Addendum No. 3
Invitation for Bids

Bid No. 08-120
ADDITIONS AND RENOVATION TO THE
HARFORD COUNTY DETENTION CENTER

July 18, 2008

3-Phase Transformer Pad Dimension Detail

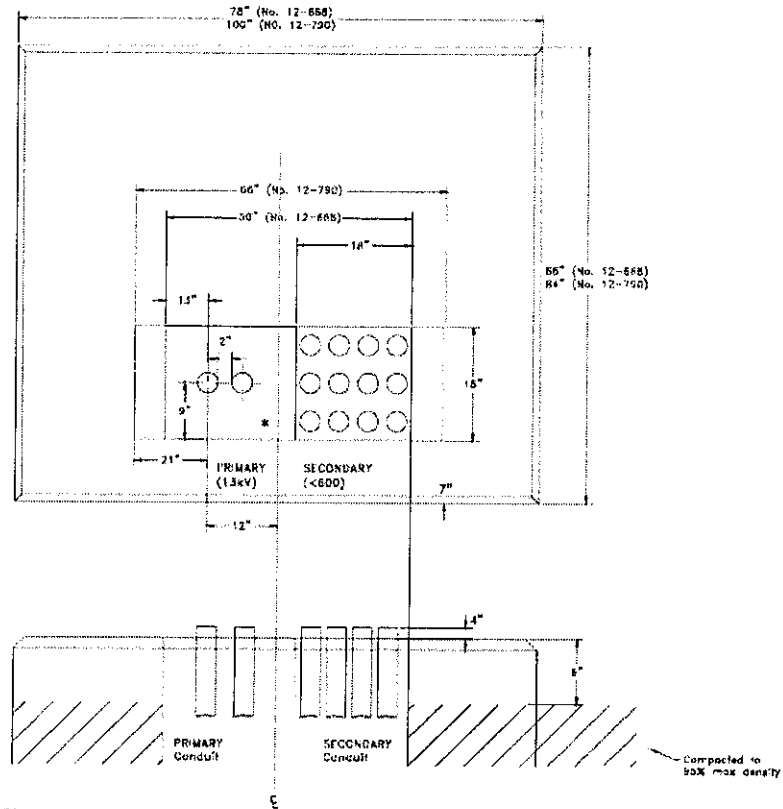
QUESTION No. 15 Detail 2 on drawings E7.2 references a transformer pad. Note 1 refers back to S7.3 for pad details. This detail on drawing S7.3 and the elevation of the transformer pad on drawing E7.7 does not match. Please advise.

Note 3 on the same detail indicates that a sump pit is to be provided for a pad mounted generator per BGE specifications. Please advise if this is correct detail for the transformer pad.

ANSWER No. 15 Construct transformer pad as per BGE requirements and dimensions for Pad No 12-790 as in BGE sketch at Attachment 1. For more details, refer to the BGE Commercial and Industrial Customer Information Booklet, available on the internet at:

Detail 2, Sheet E7.2, Note 3 incorrectly references the generator. It should reference the transformer. The sump is required.
